Source: SA WG3
Title: CR to 33.107: The use of H.248 in setting up a bearer intercept point at the MGW (Rel-5)
Document for: Approval
Agenda Item: 7.3.3

SA doc#	Spec	CR	R	Phase	Subject	Cat	Current Version	SA WG3 doc#
SP-020110	33.107	018		Rel-5	The use of H.248 in setting up a bearer intercept point at the MGW	B	5.1.0	S3-020072

CHANGE REQUEST

Title:	⌘ The use of H.248 in setting up a bearer intercept point at the MGW.		
Source:	⌘ SA WG3		
Work item code:	⌘ SEC-LI	Date:	⌘ 20 February 2002
Category:	⌘ B	Release:	⌘ REL-5
	<i>Use <u>one</u> of the following categories:</i> F (correction) A (corresponds to a correction in an earlier release) B (addition of feature), C (functional modification of feature) D (editorial modification) Detailed explanations of the above categories can be found in 3GPP TR 21.900 .		<i>Use <u>one</u> of the following releases:</i> 2 (GSM Phase 2) R96 (Release 1996) R97 (Release 1997) R98 (Release 1998) R99 (Release 1999) REL-4 (Release 4) REL-5 (Release 5)

Figure D.2: Mobile to Mobile call originating side is target

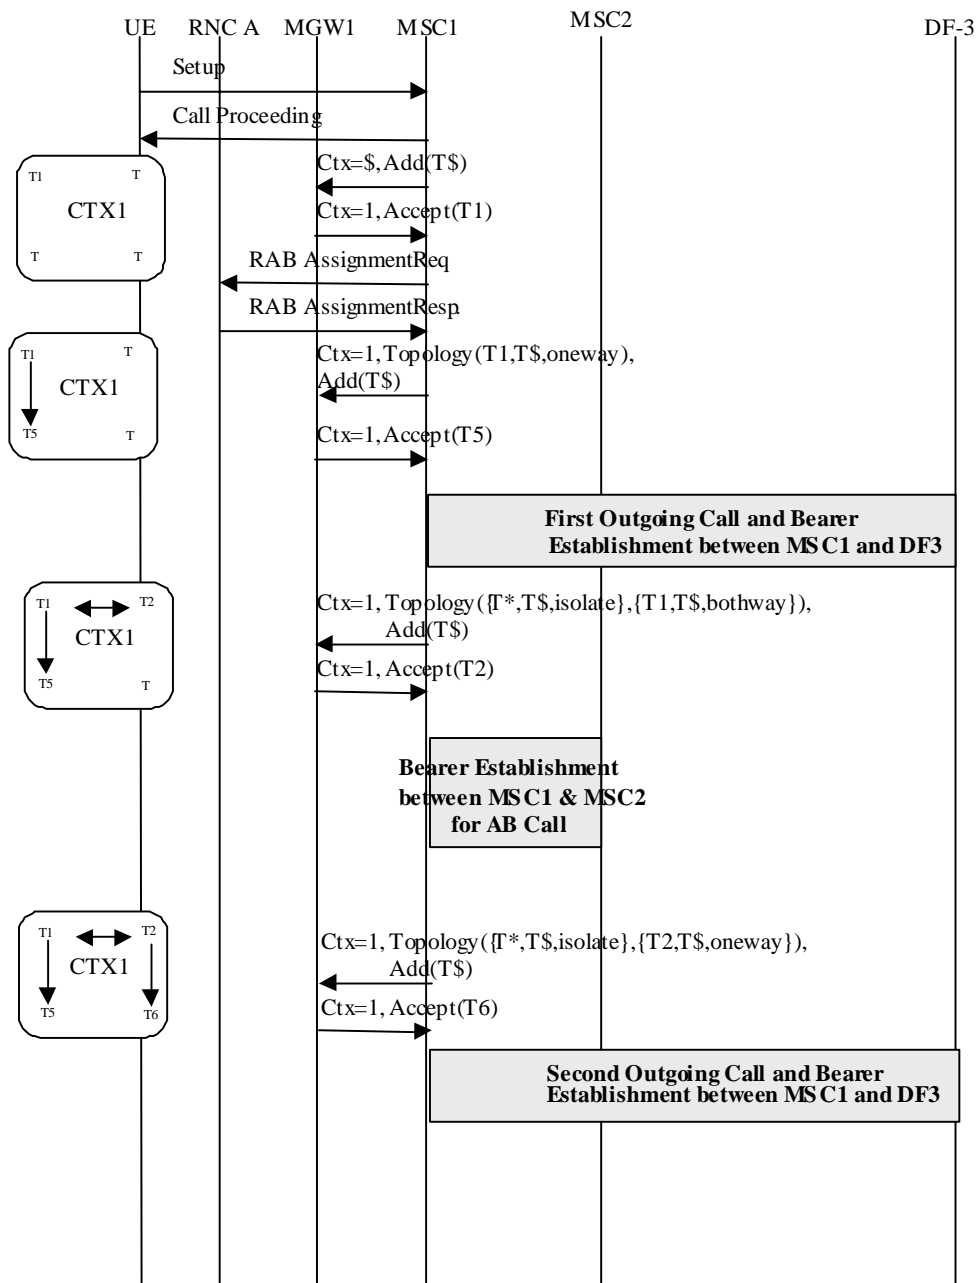
Reason for change:	⌘ Additional explanation regarding the usage of H.248 in setting up a bearer intercept point at the MGW.
Summary of change:	⌘ Additional annex for the H.248 call flows.
Consequences if not approved:	⌘ H.248 interception flows will be missing from the specification
